**Staff Report to the
Southeast Town Design Review Committee
July 14, 2016**

**MPL2016-00030
ITEM #3**

LAUREATE PARK CASITA

Figure 1—Casita First Floor Footprint on 30' x 120' Lot

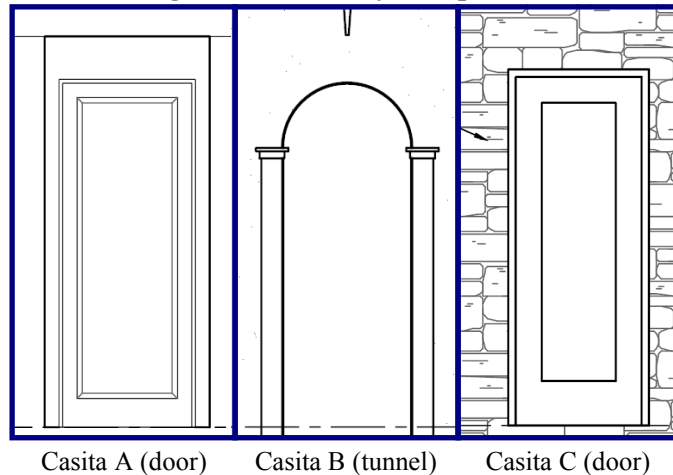
LDC Figure 68-E describes the variety of lot types in the Southeast Orlando Sector Plan. The Casita model is intended for lots 30'x120' in size, meaning it fits the Figure 68-E description for a Single Family Bungalow. Section 68.302 states, "Variation in individual housing 'types' results in different 'models'. Each model may have the same lot size and basic floor plan but is differentiated by varied exterior treatments and materials. Variations in building mass, entry and porch design, window pattern, roof form, and/or other architectural features are strongly encouraged....No street block should have more than two consecutive single family homes with the same house model." Throughout the entire Laureate Park development, the builders have provided various housing models to create a diverse community and the addition of the Casita product will contribute to this diversity and further the City's commitment toward a variety of housing types. Figure 1 illustrates the proposed building footprint on a 30'x120' lot.

Figure 2—Doorway Comparison

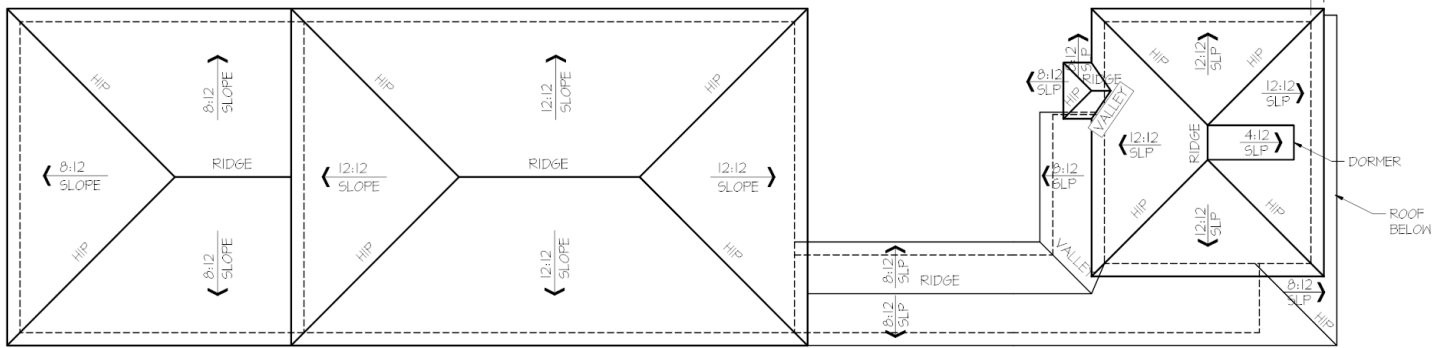
The proposed Casita models A & C feature a “faux” front door, recessed back 4 feet from the primary façade and connected to the principal unit via an arcade. Rather than a faux front door, Casita model B appears to have an empty doorway that produces a tunnel-like entrance which, as mentioned above, is specifically discouraged (see Figure 2 on page 5 for doorway comparison). In practice, the empty doorway is a common architectural feature of Casitas and shall be permitted for development subject to the conditions of this report. In particular, the applicant must include a door of decorative gate. In each Casita model, a 4 foot stoop (plus 2 feet of stairs) extends from the doorway. If it is extended to become a porch, in order to fully conform with Sec. 68.303 staff asks that the porch be a minimum 6 feet of depth, not including stairs.

If present, front porches require 6' minimum dimension from the front door, not including stairs.

A front door or decorative gate is required on the principal façade, facing the street and cannot be recessed beyond 6 feet from the principal façade. Entryways without, a door or gate shall be prohibited. A doorbell must be provided at this location.

CASITA A ELEVATIONS

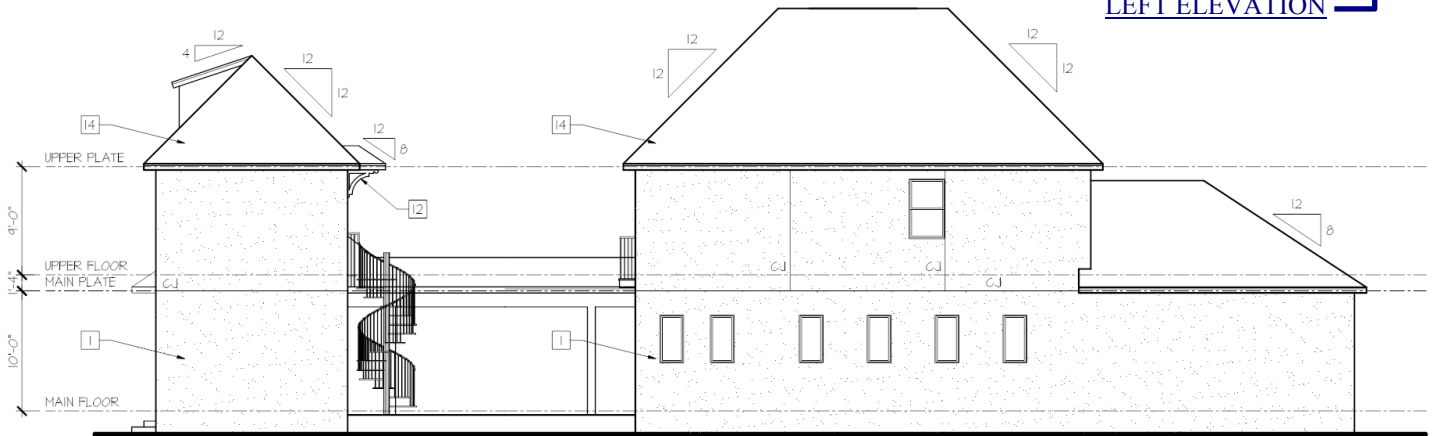
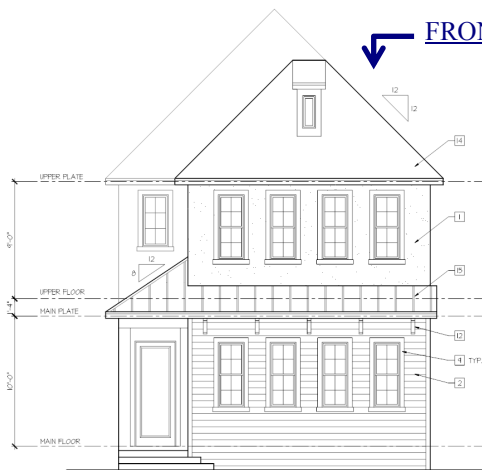
For corner lots, the street side elevation shall be the open courtyard side (example: page 6 right elevation).

Special design treatments are required for corner lots including CPTED style fencing on court yards to allow for passive monitoring of the side street.
